ADDENDUM NO. 1

Request for Proposal # 1586 Bohn – Community Kitchen

Bohn Hall - 3rd Floor
Community Kitchen Renovation
Stone Street
Montclair, NJ 07043
MSU Project No: PR23C006

MECHANICAL NEW WORK FLOOR PLAN

1 MECHANICAL NEW WORK FLOOR PLAN
SCALE: 1/4"=1'-0"

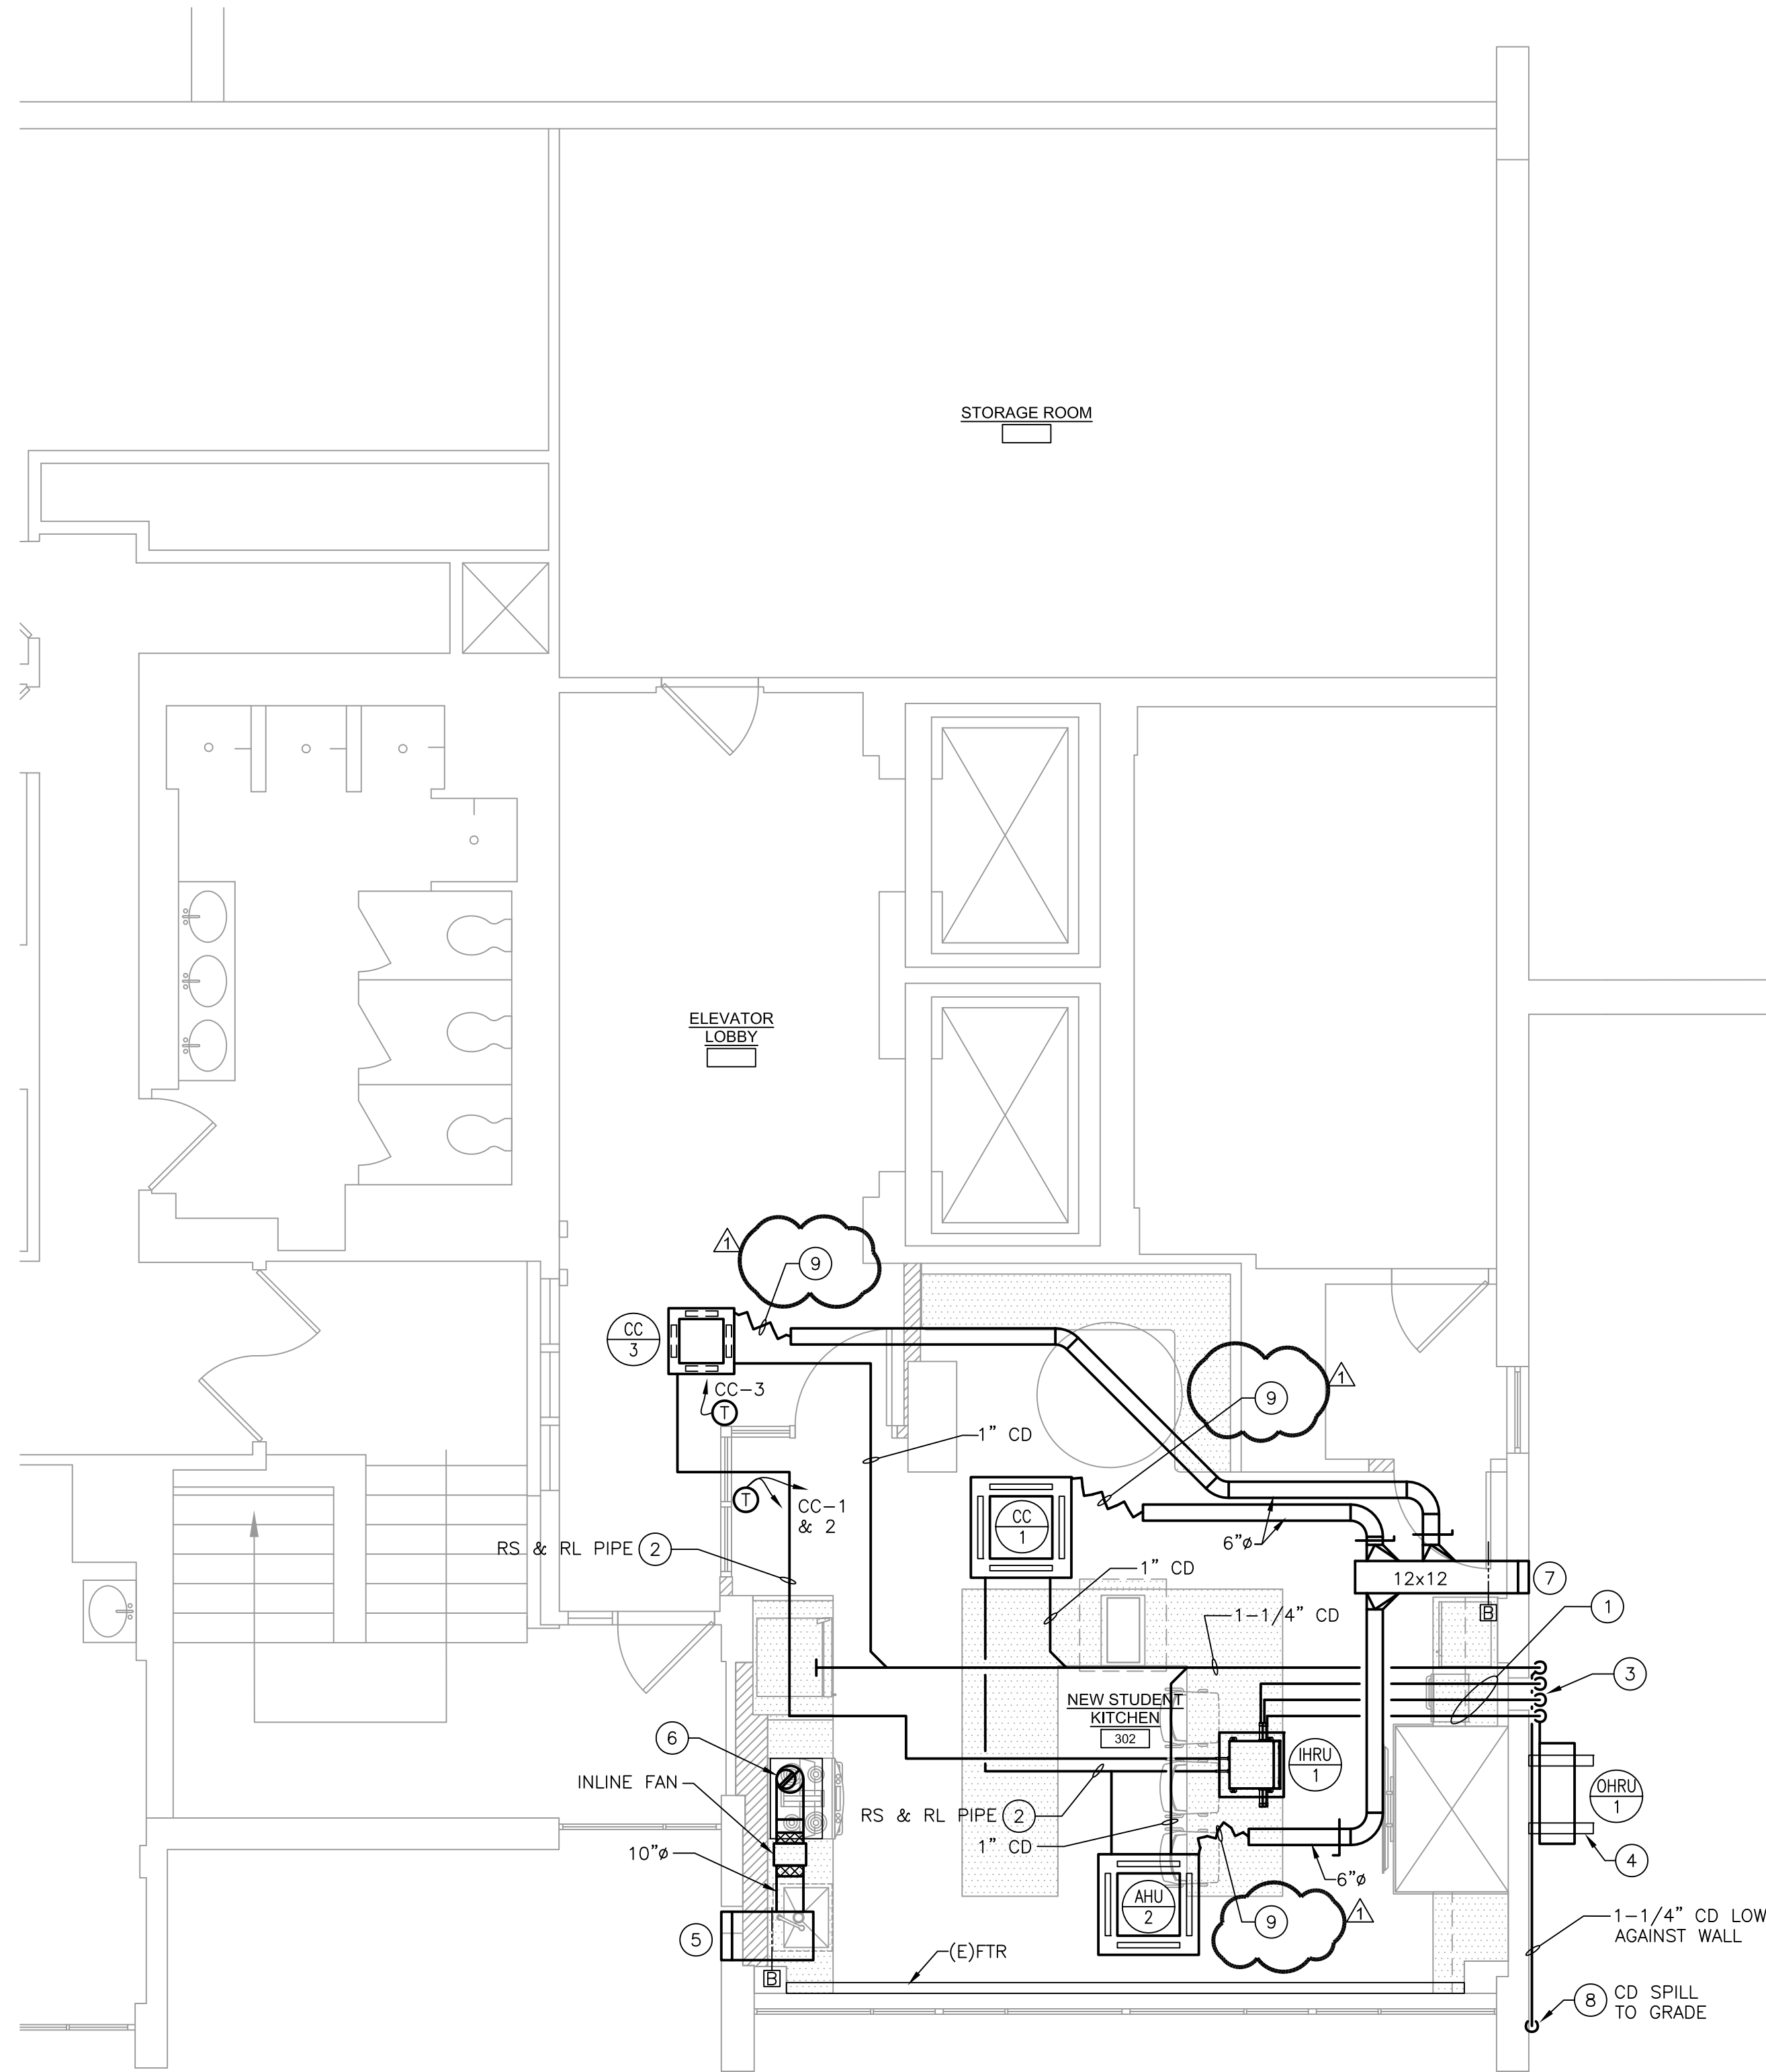
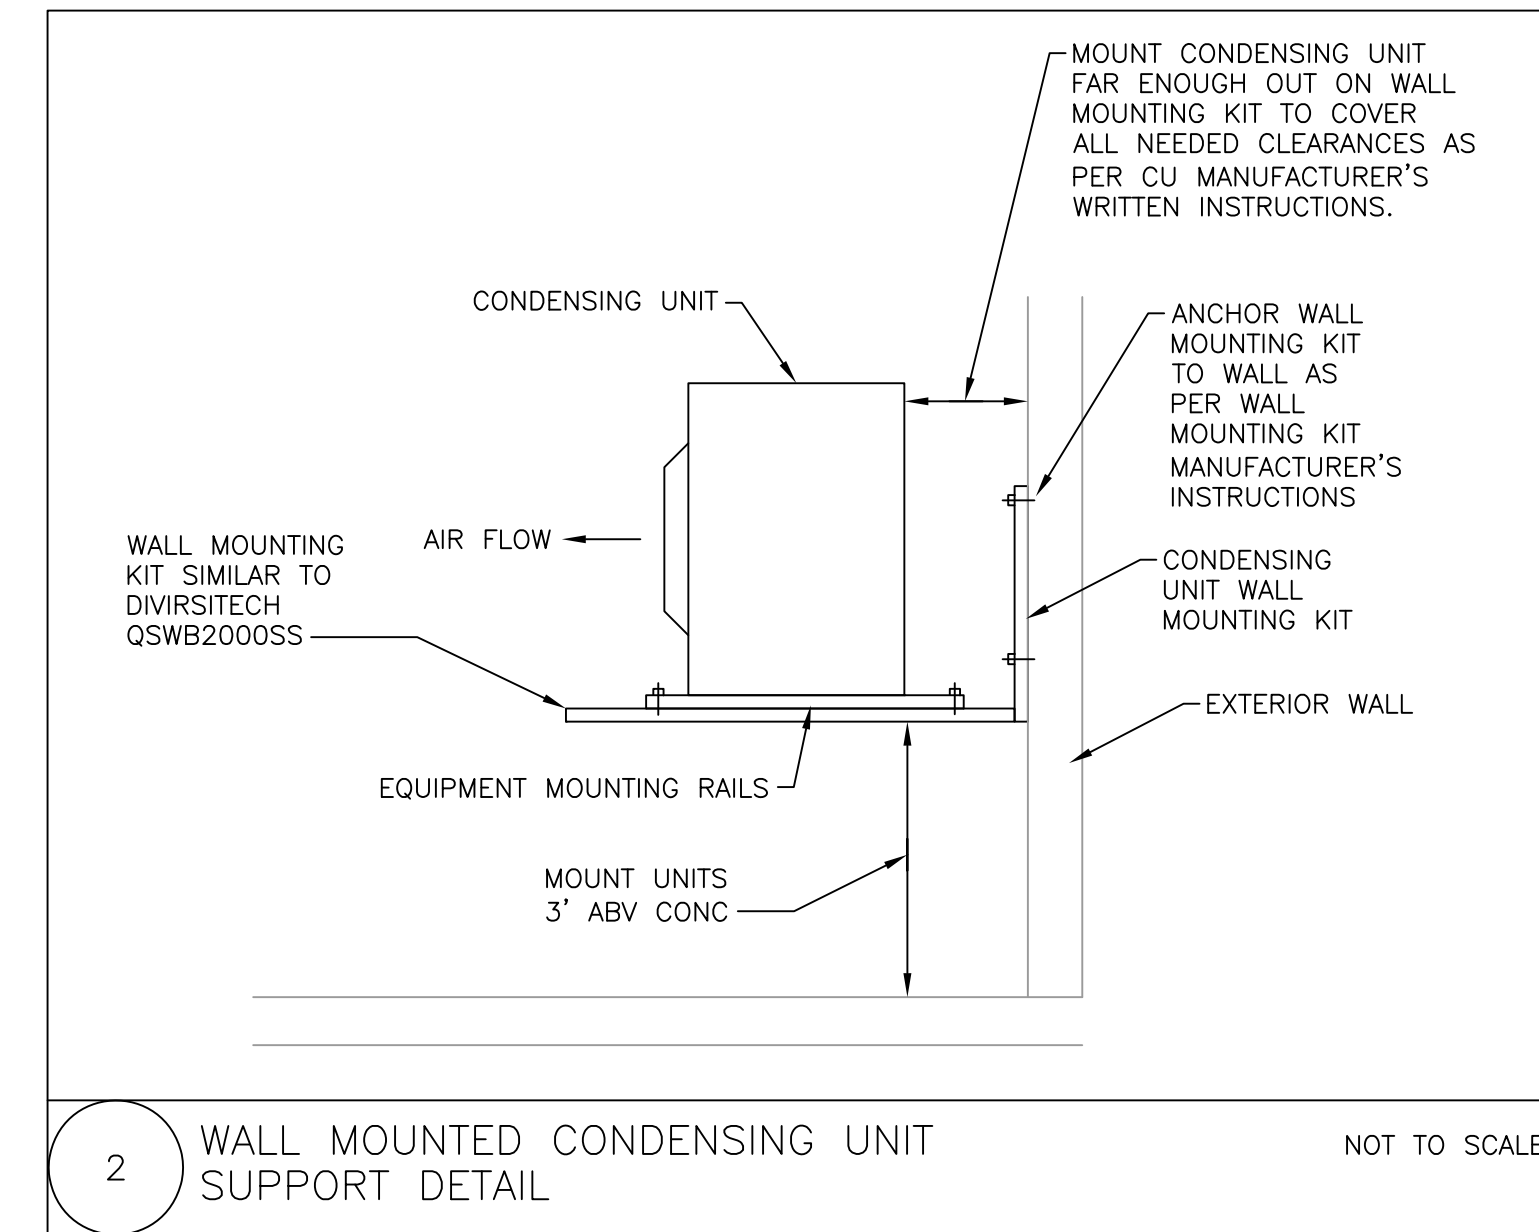
#	Additions, Deletions, Clarifications and Modifications
1	<p>On page M-100, it shows fresh air ducting with 6" branch lines; where those branch lines end, it shows that it converts to a flex, but it does not show what size flex it is, and it does not show what vent it goes to.</p> <p>Refer to the attached revised Drawing Sheet M-100. Ceiling Cassette Units have been updated to include ventilation kits and flex ducts have been labeled as a 6" round size with any required transitions as needed to connect to the unit ventilation kit.</p>
2	<p>Attached to this Addendum is a drawing that shows the path from the loading dock to the space by way of the stairs instead of the elevator. If this path is used during any part of the construction, the contractor must provide protection and coordinate with Res Life as the path goes by rooms that students could occupy.</p>

- 9 6" FLEX DUCT TO VENTILATION KIT CONNECTION OF CEILING CASSETTE UNIT. PROVIDE ANY REQUIRED DUCT TRANSITIONS AS REQUIRED TO CONNECT FLEX DUCT TO VENTILATION KIT CONNECTION.
